# intel® Technical Advisory

TA-0673-3

## Intel® Server Chassis SC5200 Base Redundant Power Supply Module Diode Issue

Figure A – Manufacturing Label With Blue Slash (Line) Indicates A Reworked Power Supply

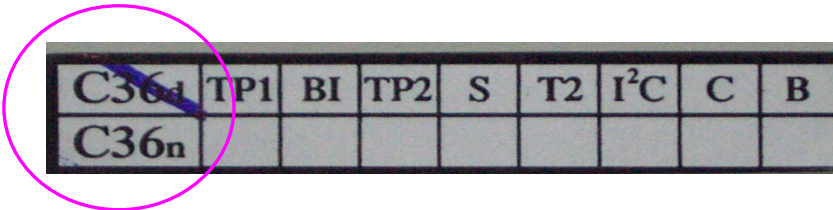
The power supply vendor is reworking some power supplies within the potentially affected power supply module serial number range with diodes not affected by this issue. Reworked power supplies are not vulnerable to this issue. Reworked power supplies will be marked with a blue slash (line) on the power supply module manufacturer's label. An example of the blue slash is shown in the following Figure A photograph.

If customers identify power supply modules with serial numbers in the potentially affected serial number range, Intel recommends performing a replacement of the power supply modules during the system's next preventative maintenance schedule. Customers may replace a power supply module in a non-redundant system configuration without requirement for a system power-down by using a second spare power supply module to keep the system powered on while the other module is replaced. This requires that the customer have two AC power supply cords connected to the system. Customers who have potentially affected power supply modules may request replacement of their power supply modules. To obtain replacement power supply modules, contact Intel using your normal warranty process. Please indicate that you are calling regarding TA 673-3 and have the part number and the serial numbers for the systems needing the replacement part.
